Subject: PUBLIC HEARING – Comprehensive Plan Amendment, Preliminary Rezoning, & Preliminary Development Plan. Frauenshuh Commercial Real Estate. 5125, 5105, 5101, and 5108 Edina Industrial Boulevard and 7700 Ni Boulevard. Res. No. 2014-82, Comprehensive Plan; and Res. No. 2014-83 for Preliminary Rezoning and I

**VII. C. Rezoning, Comprehensive Plan Amendment & Variances.
Frauenshuh. 5108 Edina Industrial Boulevard, Edina, MN**

PLANNING COMMISSION STAFF REPORT

DATE: July 15, 2014
TO: Cary Teague – Planning Director
CC: Chad Millner – City Engineer
FROM: Ross Bintner P.E. - Environmental Engineer
RE: **5108 Edina Industrial Blvd – Development Review**

• GRADING & DRAINAGE PLAN

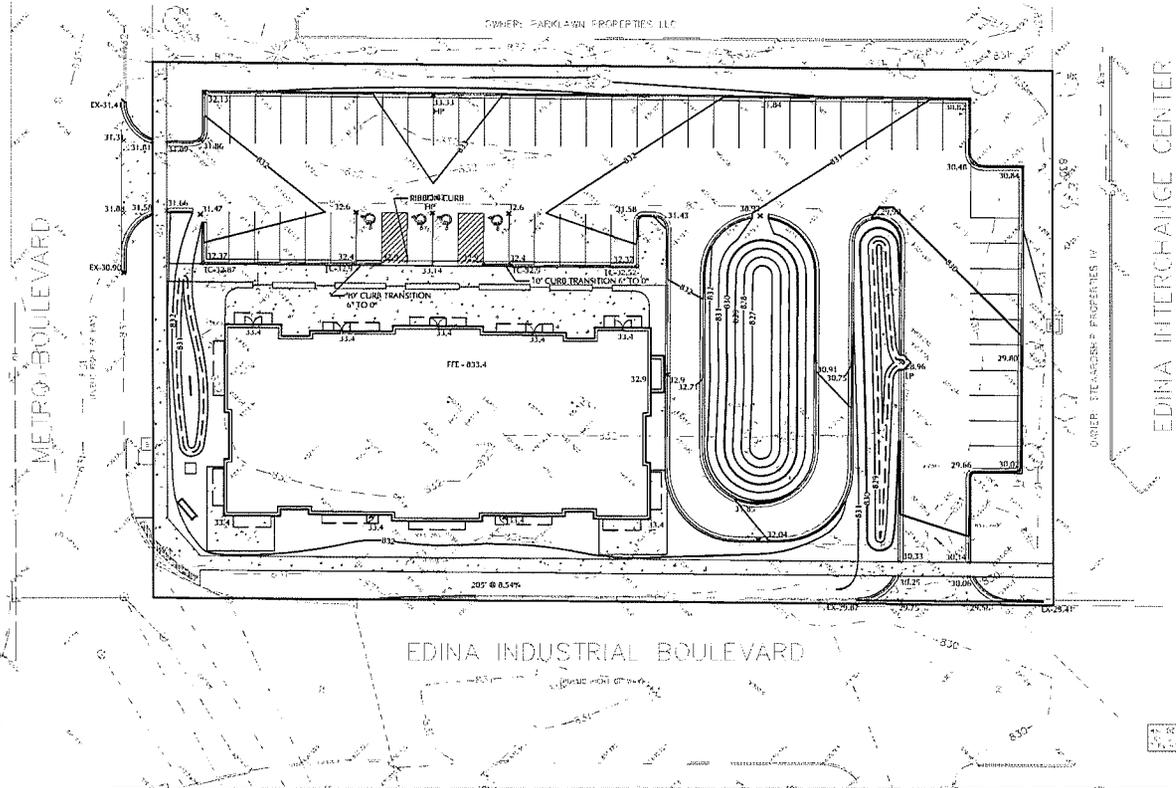
Commissioner Schroeder said he has an issue with drainage noting off Metro Boulevard there is a low area along the sidewalk that could flood during a heavy rainfall. He added in his opinion it's not a good idea to have people walk to the building through a stream of water. Mr. Sperides agreed, adding he would review the engineering drawings and "take care" of any drainage issues.

SITE PLAN OPTION A

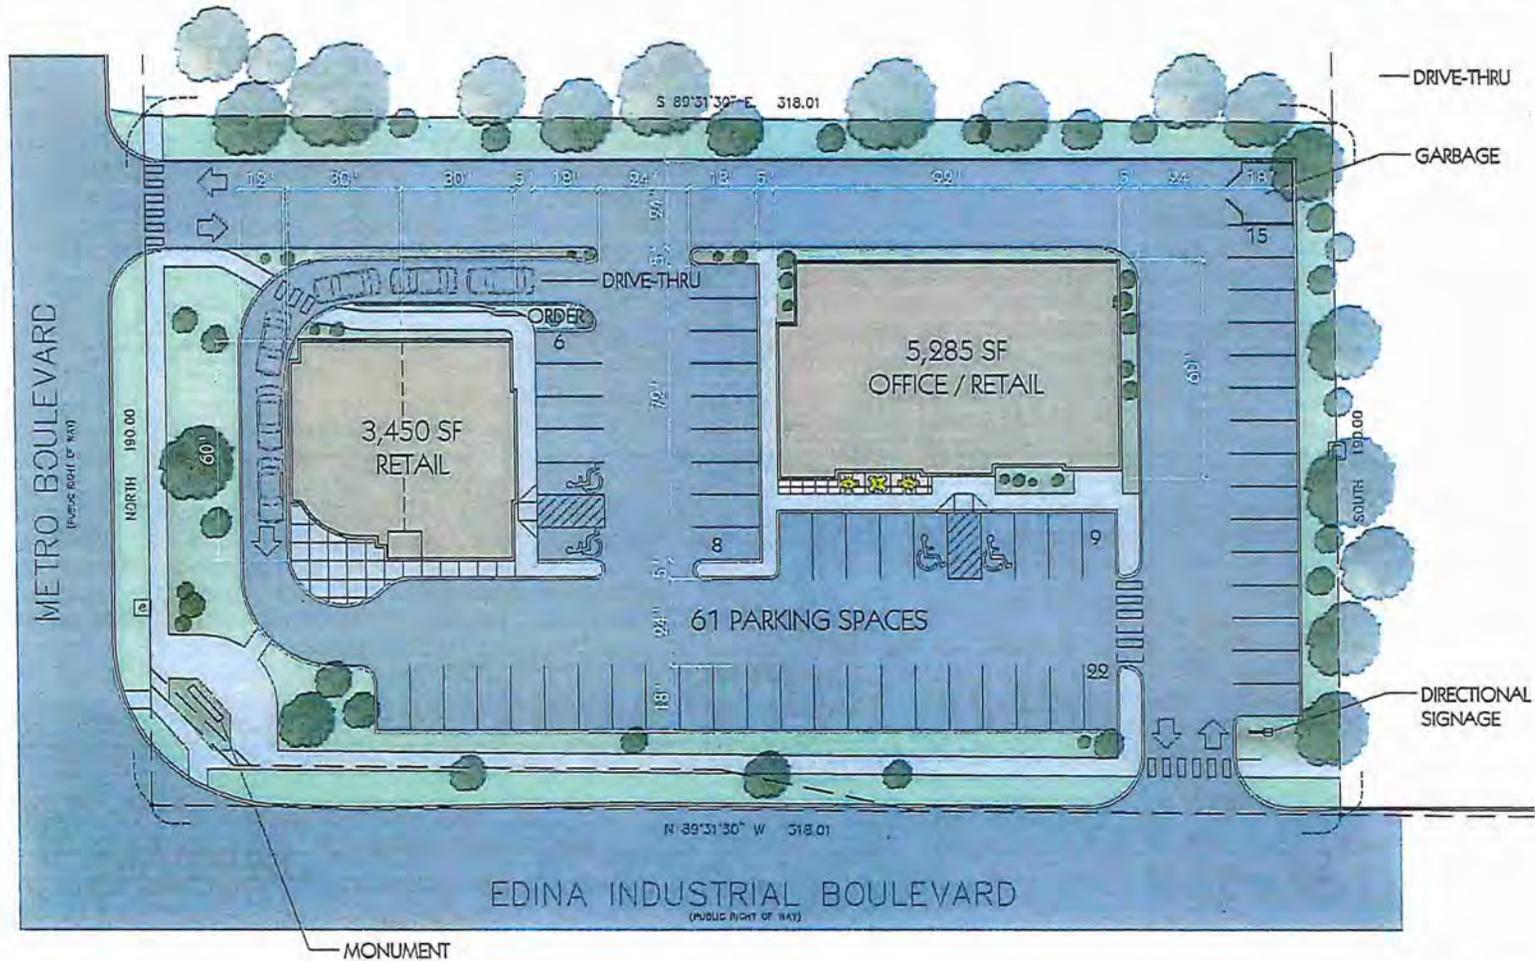
11. Show existing utility connections.
12. Relocate hydrant at corner of Metro/Edina Industrial out of sidewalk area, avoid conflict with monument signage.
